ROADWAY DESIGN BULLETIN 22-04

SUBJECT: **Audible and Vibratory Treatments for Arterials and Collectors**

This Bulletin introduces revisions to the *FDOT Design Manual (FDM)* and *FDOT Standard Plans for Road and Bridge Construction (Standard Plans)* to streamline and improve the Department's criteria and construction details for Audible and Vibratory Treatments (AVTs) on arterials and collectors.

INDEX
546-010-1

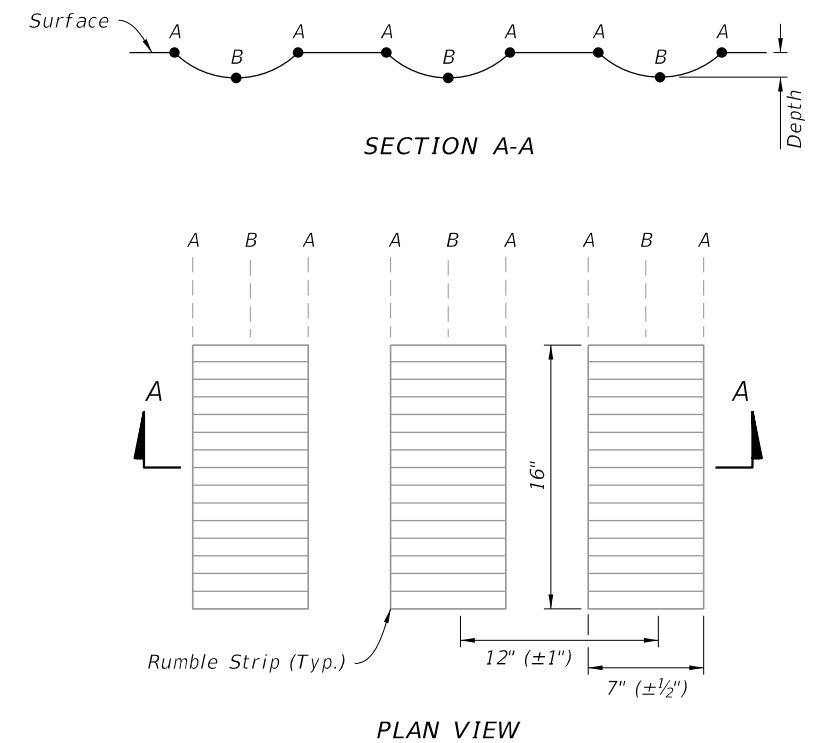
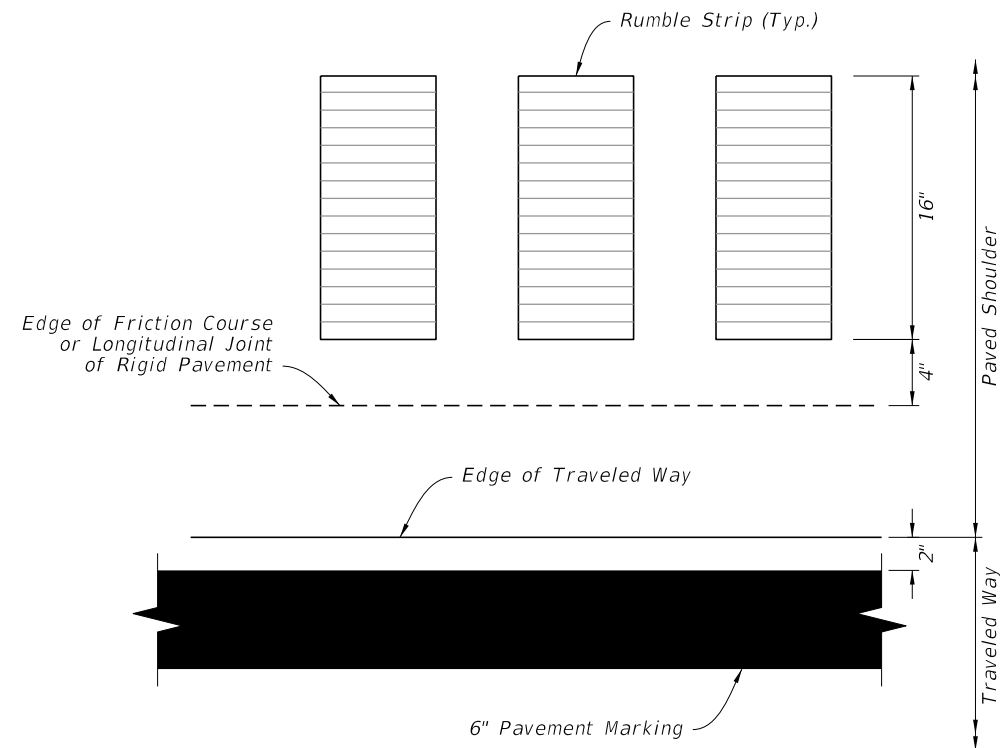
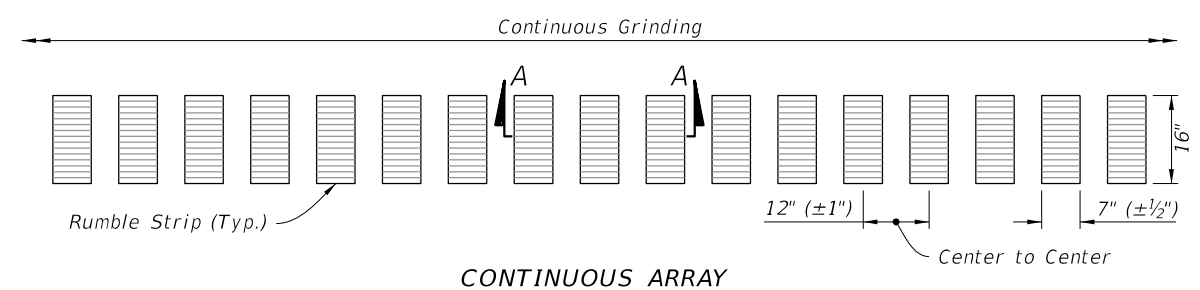
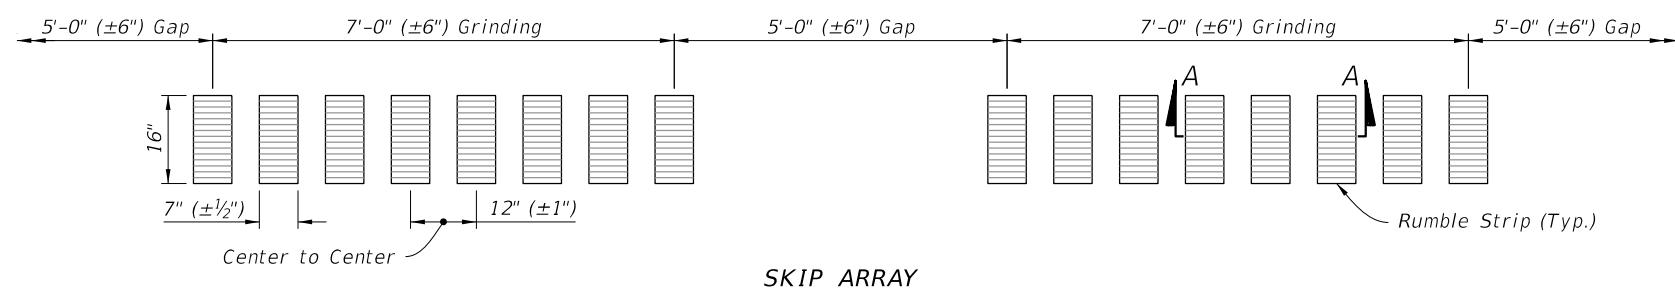
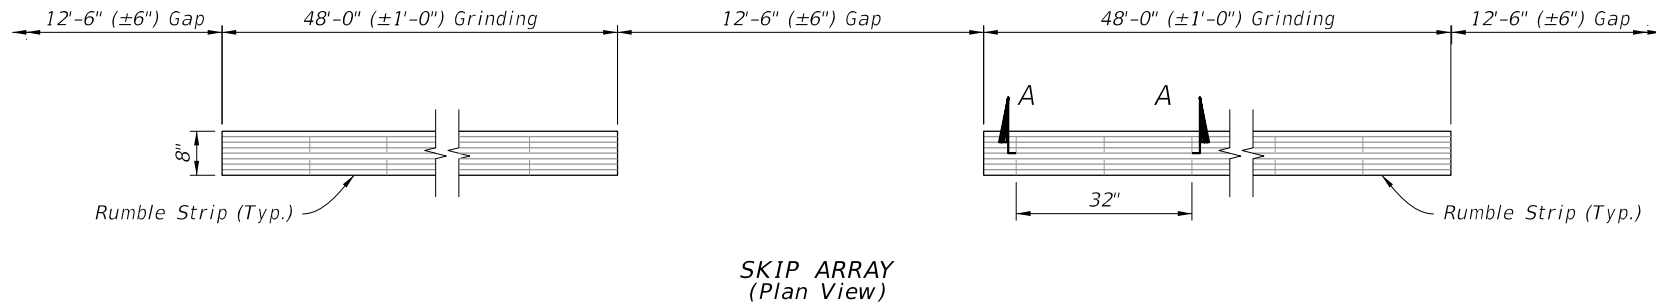
DESCRIPTION:
Revised Index to only include cylindrical rumble strips for limited access facilities.

INDEX
546-020

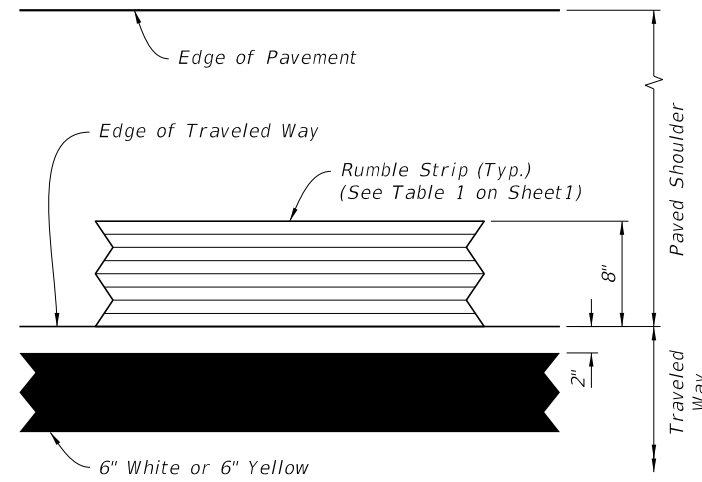
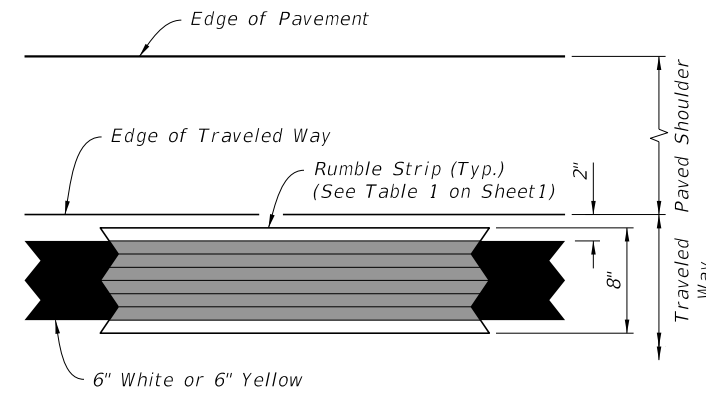
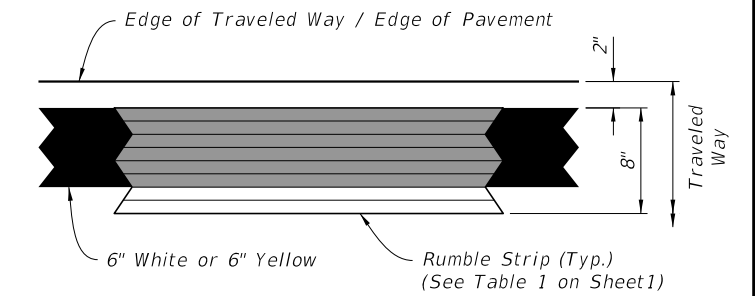
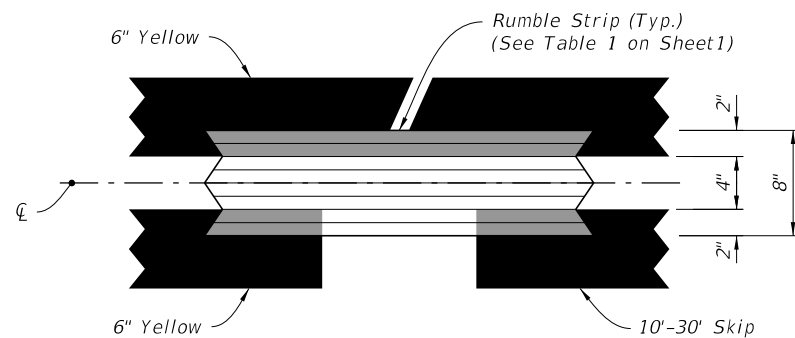
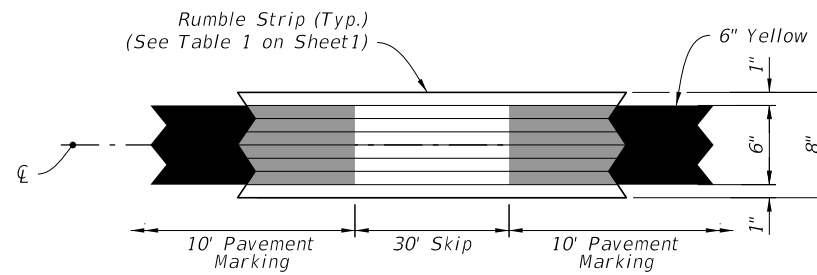
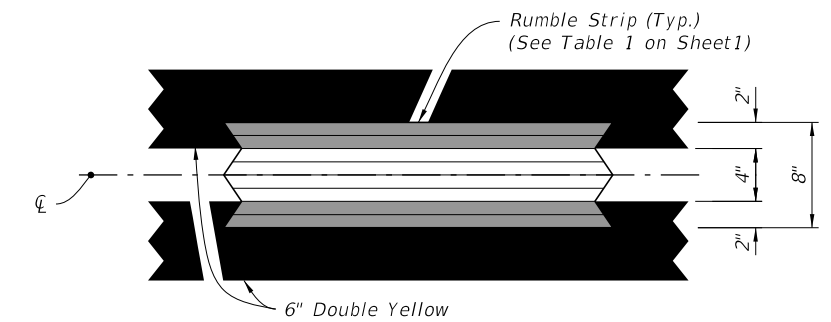
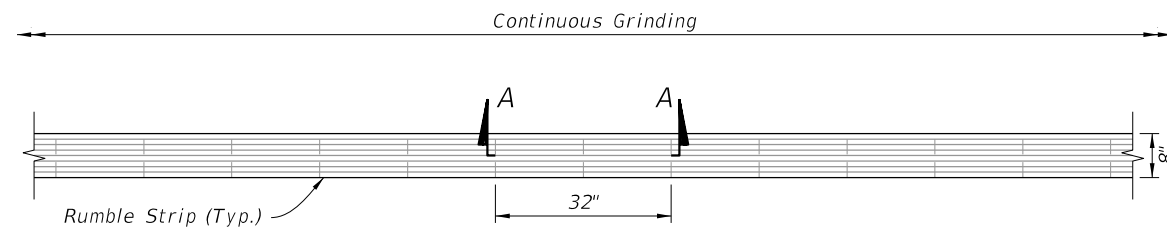
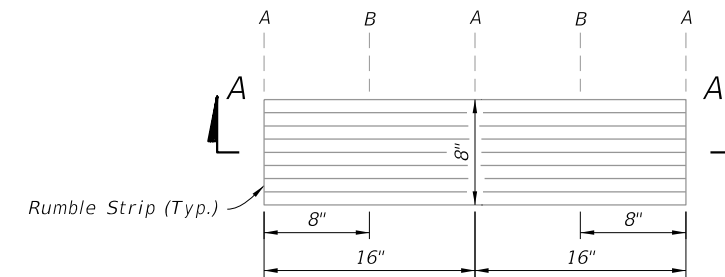
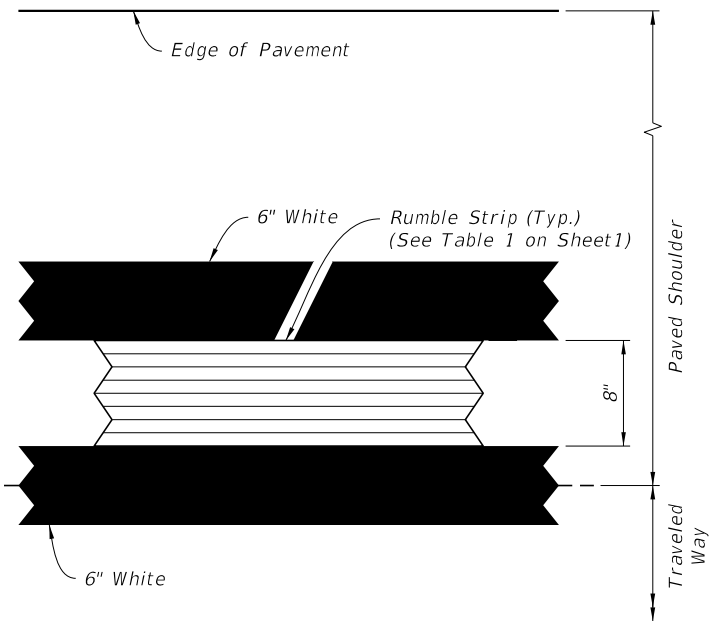
REVISION DESCRIPTION:
New Index to only include sinusoidal rumble strips for arterials and collectors.
